April 29, 1994
LD-94-032

Docket No. 52-002

Subject: Response to Comments on Design Certification Material

CE 80 + ITAAC Independent Review Comments

FIGURE 2.3.3-1
REACTOR VESSEL SUPPORTS

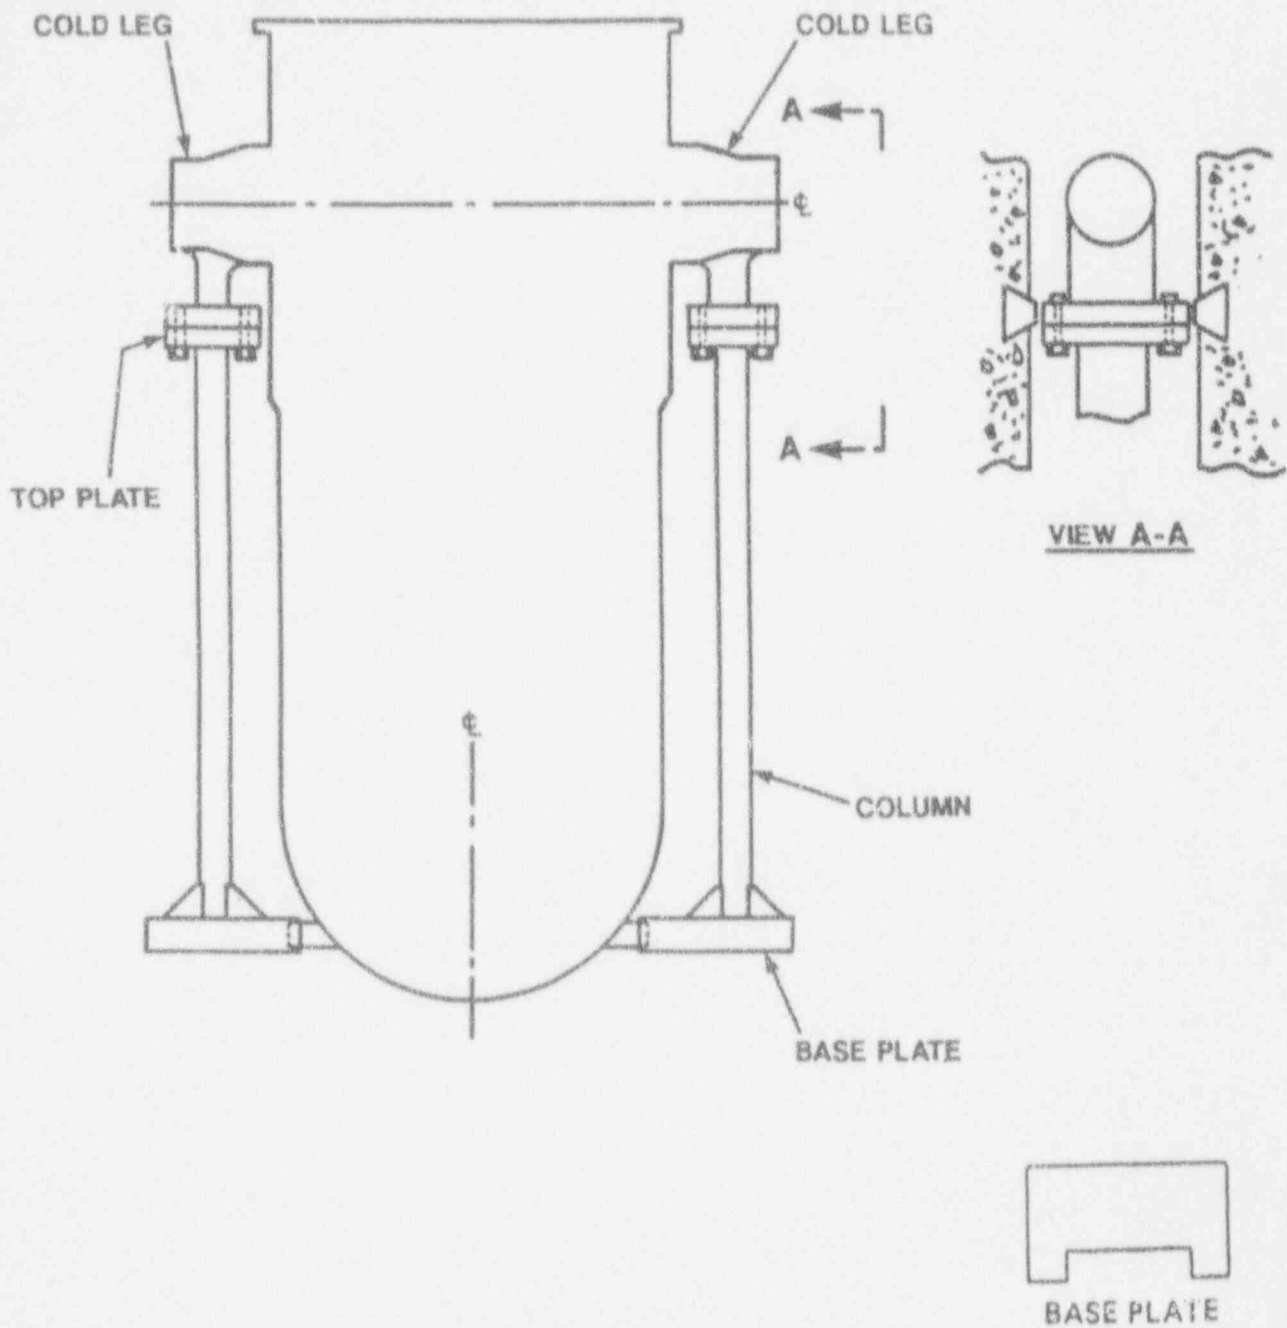
No.	Comments	Cat.	Resolution
1	CDM Figure 2.3.3-1 provides no details on the base plate slots as described in the design description. Revise ITAAC item 3 to verify the basic configuration conforms with the "design description" which includes both text and figures.	1	Agree. ITAAC Figure 2.3.3-1 is changed as shown on the marked revision page to be consistent with the design description and CESSAR-DC. No change to CESSAR-DC is required.

FIGURE 2.4.1-1
SAFETY DEPRESSURIZATION SYSTEM

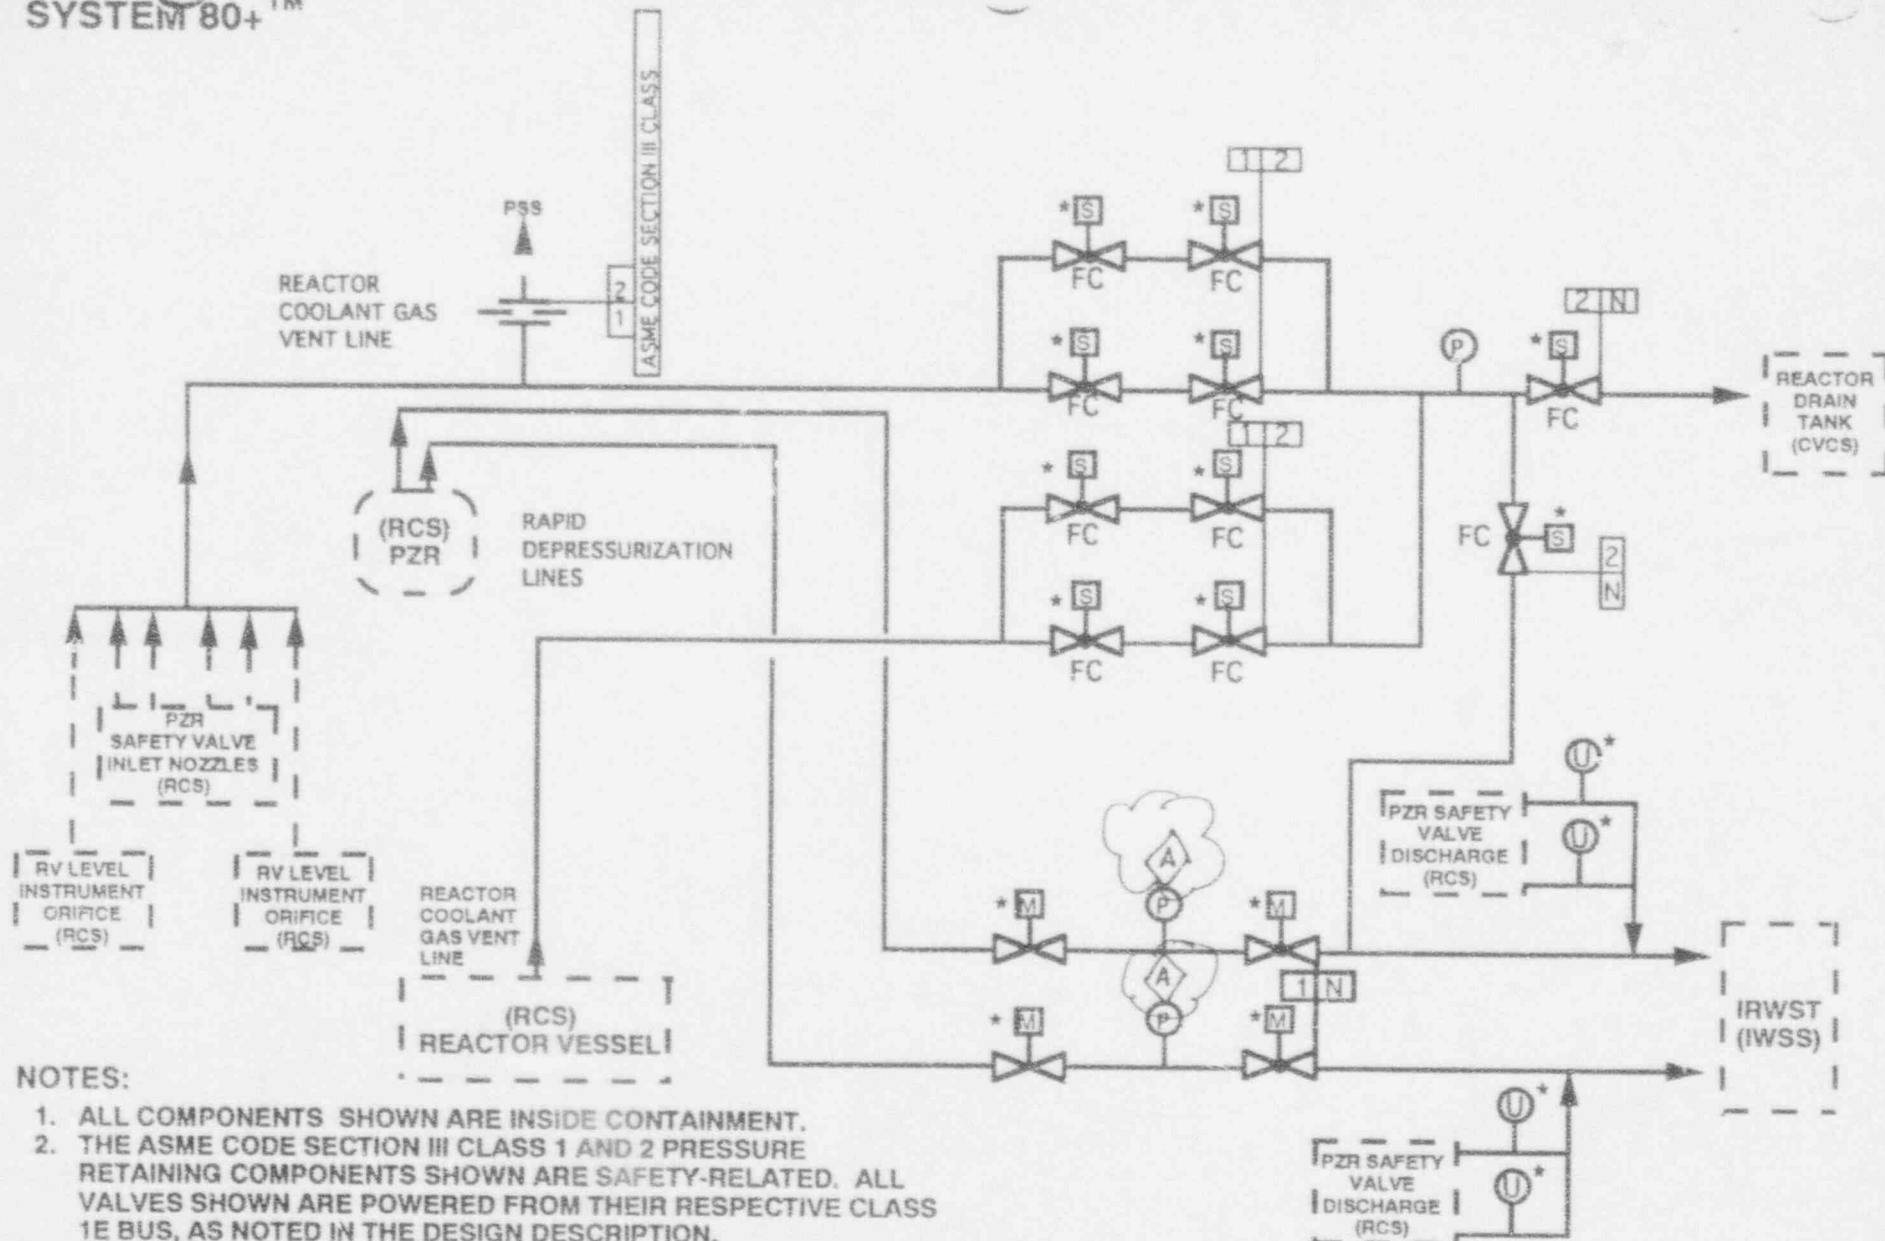
No.	Comments	Cat.	Resolution
1	Design Description and ITAAC 5c. state that alarms shown on Figure 2.4.1-1 are provided in the MCR. But the figure does not show any alarms.	1	<p>ABB-CE agrees. Figure 2.4.1-1 will be revised to add alarms on the RDS line pressure instruments, as shown in the attached markup.</p> <p>NRC Staff concurs.</p>
2	The temperature indicators on the PZR safety valve discharge lines should be shown on Fig. 2.4.1-1.	1	<p>ABB-CE disagrees. The temperature instruments on the PZR safety valve discharge lines perform no safety-related function, nor are they required for post-accident monitoring by Reg. Guide 1.97.</p> <p>NRC Staff concurs.</p>
3	The acceptance criteria in ITAAC 2 is only applicable to the pressurizer vent portion of the RCGVS according to Chapter 6.7.1.2.1 of CESSAR. A different criteria for the RVUH vent portion is given in the CESSAR. This should be reconciled.	1	<p>ABB-CE disagrees. Per previous agreement with the Reactor Systems Branch, the RCS depressurization rate using the RCGVS RVUH vent path is not required in ITAAC. The success of the natural circulation cooldown analysis is not sensitive to the RVUH depressurization rate, and is therefore not as significant as the depressurization rate using the RCGVS PZR vent. Pre-operational testing and analyses will be performed for both vent paths as described in CESSAR DC Sections 6.7.4.1 and 14.2.12.1.39 to verify the RCS depressurization rates stated in Section 6.7.1.2.1 and assumed in the NCC analysis in Appendix 5D.</p> <p>NRC Staff concurs.</p>

FIGURE 2.4.4-1
SAFETY INJECTION SYSTEM
(ONE OF TWO DIVISIONS)

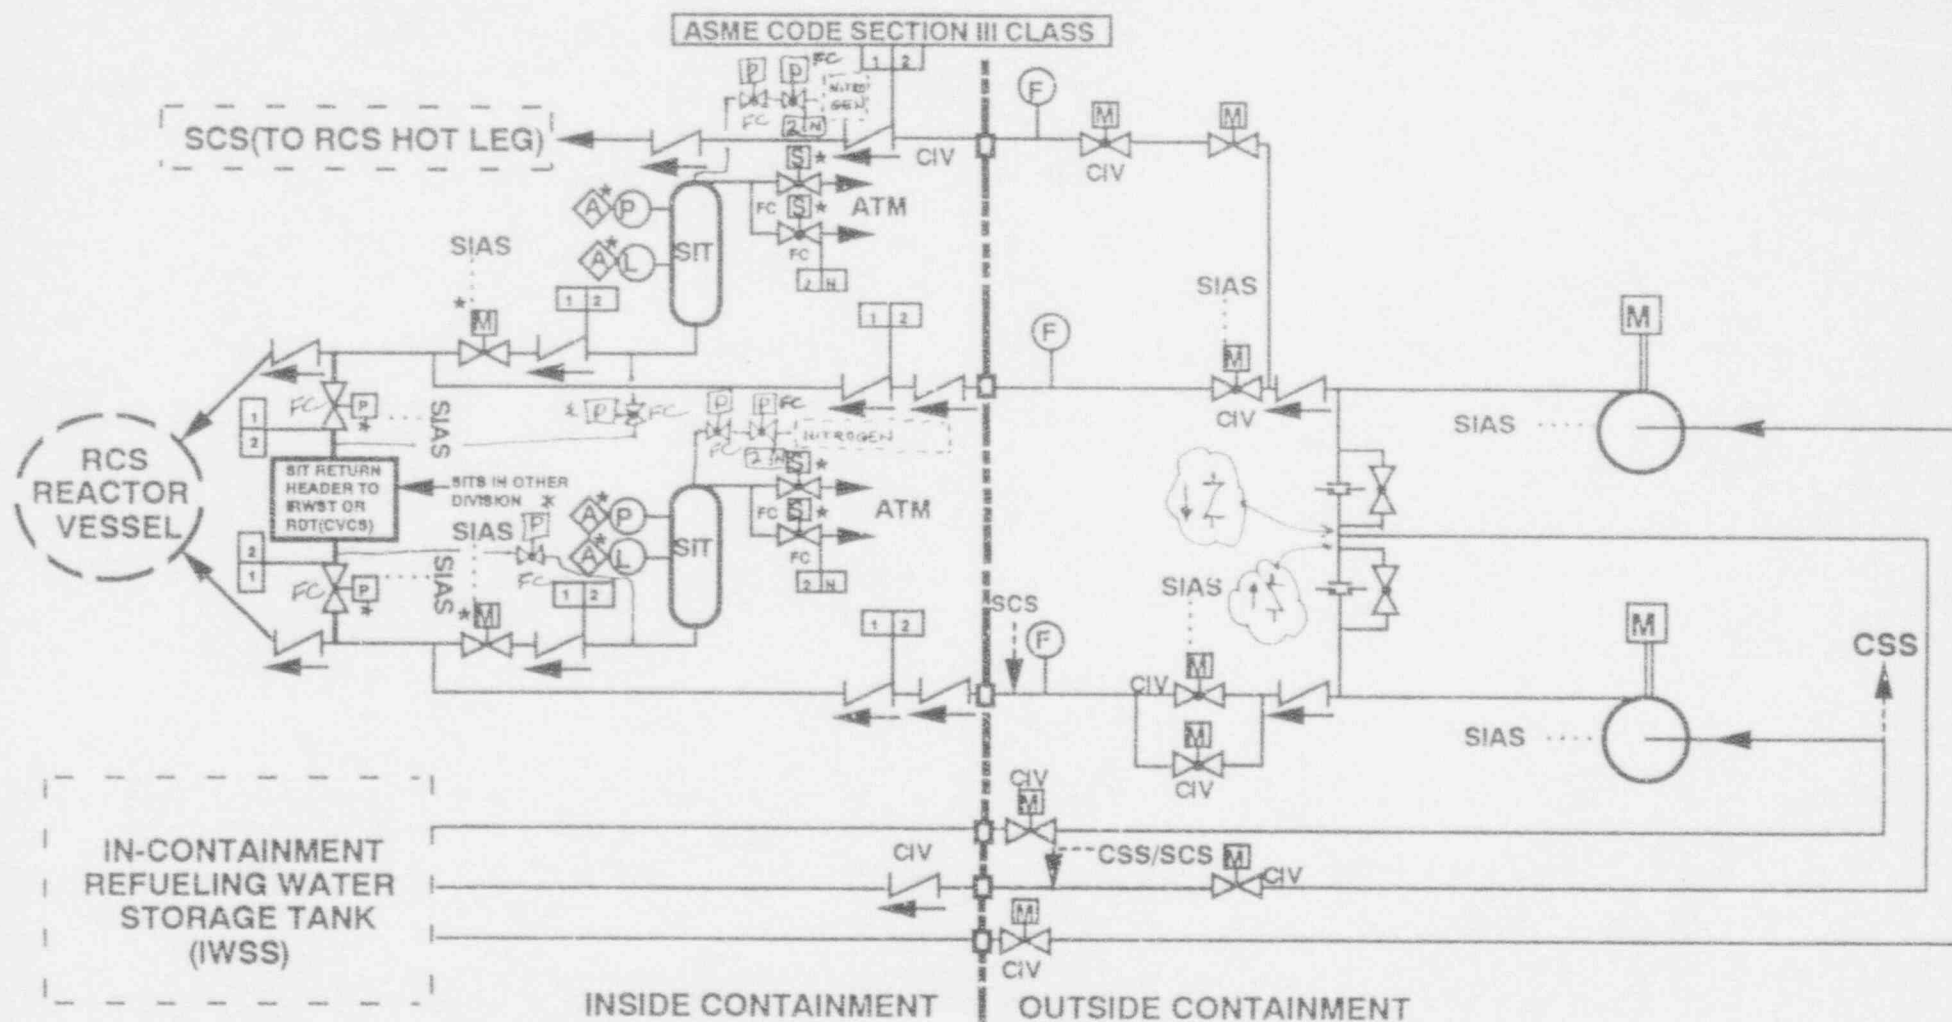
No.	Comments	Cat.	Resolution
1 (2)	The safety-related portion of the nitrogen cover gas piping and valves and the fill line to the SIT should be shown on Fig. 2.4.4-1.	1	<p>ABB-CE agrees. The safety-related portion of the nitrogen cover gas connections to the SITs will be added to Figure 2.4.4-1, as shown on the attached markup.</p> <p>NRC Staff concurs.</p>
2 (3)	ITAAC 2 should include verification of the minimum volume in the SIT used as input parameter for CESSAR Chapter 6 analysis. Also, the SIT low level alarm setpoint should be verified to assure that the required min. volume is available in the tank.	1	<p>ABB-CE disagrees. The Chapter 6 and 15 analyses assume SIT water volumes based on the Tech Spec limits. Water level and alarm setpoints are operational considerations and not appropriate for ITAAC.</p> <p>NRC Staff concurs.</p>
3 (4)	The SI pump differential pressures in ITAAC 2 acceptance criteria could not be found in CESSAR 6.3. The required flows at the DVI nozzle pressures used in the DBA analysis (for example, selected data points from CESSAR Table 6.3.3.3-1 or Table 6.3.2-5) should be specified as acceptance criteria. Specifying pump differential pressures without stating the limits on as-built system hydraulic resistance is incomplete.	1	<p>ABB-CE disagrees. The SI pump differential pressures specified in ITAAC 2 correspond to the RCS pressures for zero injection flow in CESSAR DC Tables 6.3.2-5 and 6.3.3.3-1. With no injection flow (pump at minimum recirculation flow), there is no hydraulic resistance in the injection line. The elevation difference between the water source (IRWST) surface and the DVI nozzles is neglected.</p>

FIGURE 2.4.5-1 (PAGE 1 OF 4)
CONTAINMENT ISOLATION VALVE CONFIGURATION

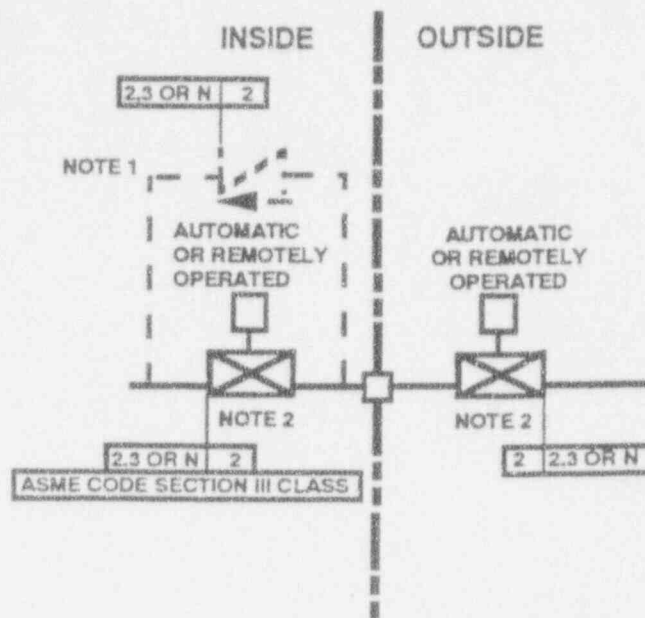
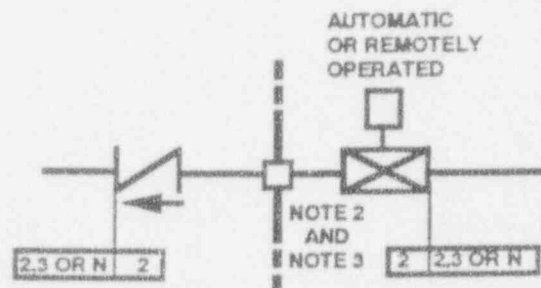
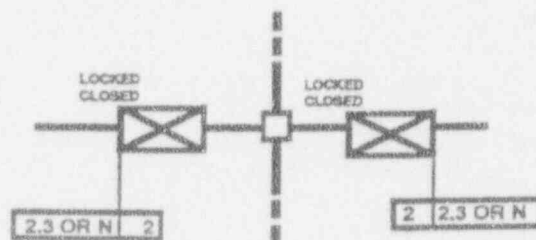
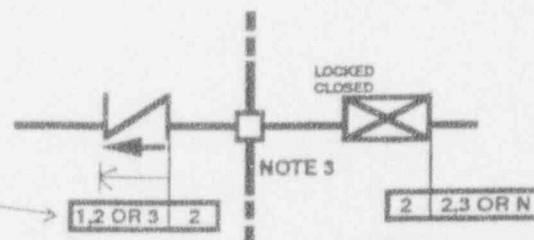
move tag to
left side of
valve

FIGURE 2.4.5-1 (PAGE 4 OF 4)
CONTAINMENT ISOLATION VALVE CONFIGURATION

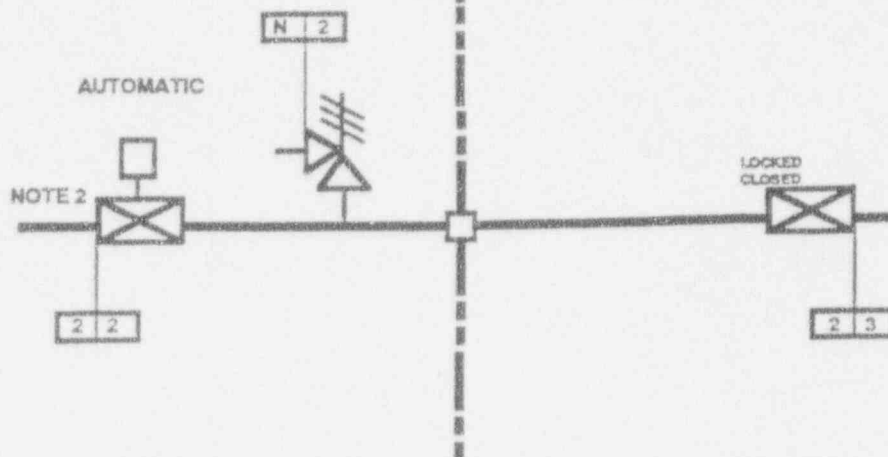
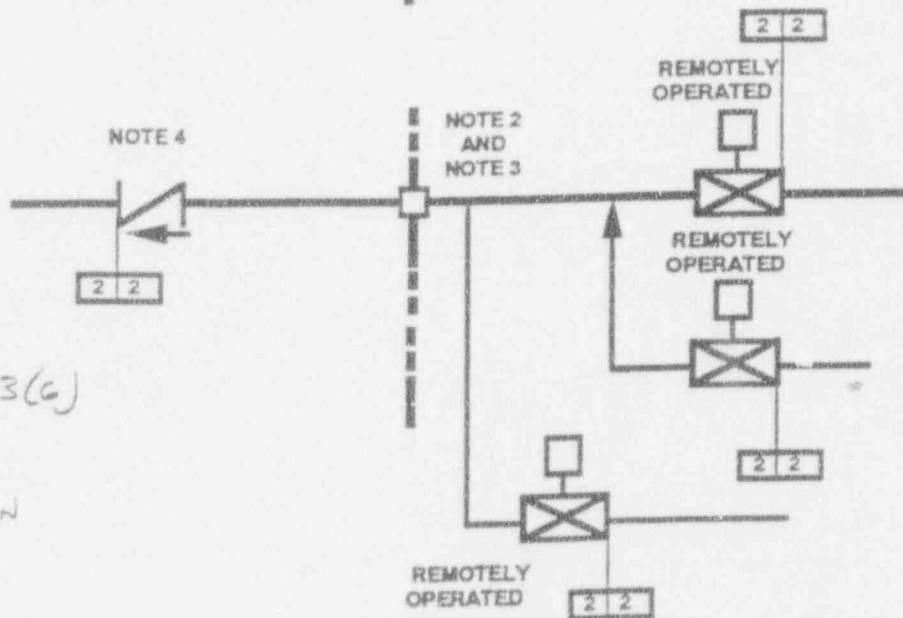
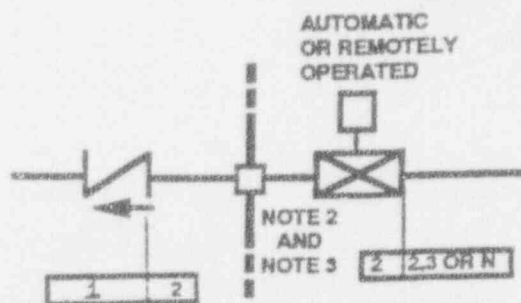
3 (6)	Table 2.4.5-2 Items 19 & 20 corresponding to Figure 2.4.5-1 Arrangement 2: the inside containment check valve is shown as ASME Section III Code Class 2 whereas CESSAR Figure 6.3.2-1C is showing Code Class 1. Please resolve this discrepancy.	1	Agree. Comment is that for hot leg injection penetration, the configuration on CDM Figure 2.4.5-1 doesn't show the class break from 2 to 1 (towards containment). The valves in question are Class 1 valves. Therefore a new configuration will be added to Figure 2.4.5-1. See markup of the ITAAC

Comment 3(6)
Add this
Configuration
